PLANNING, ZONING, & BUILDING DEPARTMENT
PZ&B Staff Combination Memorandum: Architectural Commission and Town Council

SUBJECT: ARC-23-159 (ZON-24-005) 288 SANDPIPER DR (COMBO)

MEETING: DECEMBER 15, 2023 ARCOM
JANUARY 10, 2024 TC

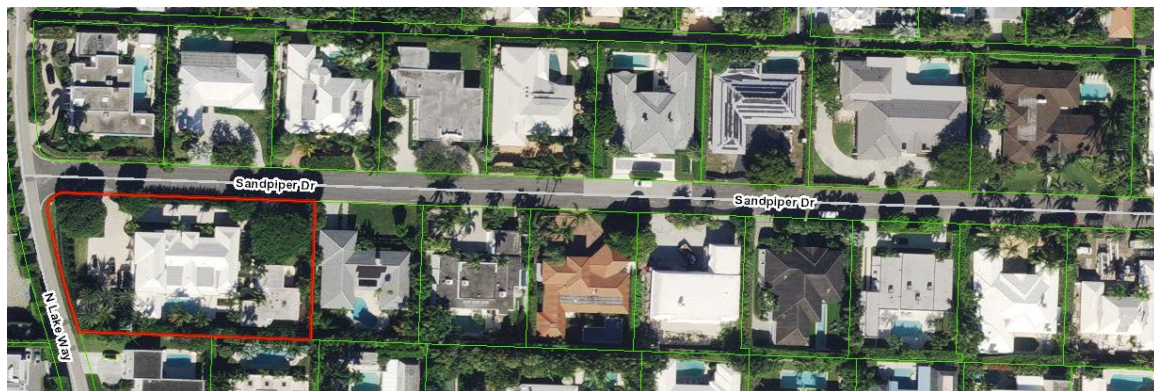
The parcel at 288 Sandpiper Drive is a corner parcel bounded by Sandpiper Drive to the north, North Lake Way to the west, and residences to the east and south. The lot encompasses 30,000+ SF of area, an oversized parcel in the R-B zoning district. Properties over 20,000 SF in R-B zoning district are subject to more strict zoning regulations which normally apply to properties located in the Estate (R-A) or Large Estate (R-AA) residential districts. The property is currently improved with a two-story main residence, a single-story guest house, with hardscape and landscape improvements. The application seeks to modify the existing guest house by enclosing unenclosed covered portions of the structure and construction of a small (approx. 20 SF) addition. Portions of these improvements are occurring within the required rear yard setback area, and a variance is being pursued. Finishes on the accessory structure are proposed to match the primary residence. The application contains one (1) variance request: for setback encroachments. As the diagrams

below illustrate, the variance occurs at the south rear-yard setback area. It may be worth noting that for a lot under 20,000 SF in R-B zoning, this setback would be conforming. The increased setback to 15' is due to the oversized parcel.

Code Section	Required	Proposed	Variance
VARIANCE 1: Sec. 134-893(b)(1)(c)	Minimum South Rear Yard Setback of 15'	South Rear Yard Setback of 10.4'	4.6' <i>Existing and proposed guest house encroachment.</i>
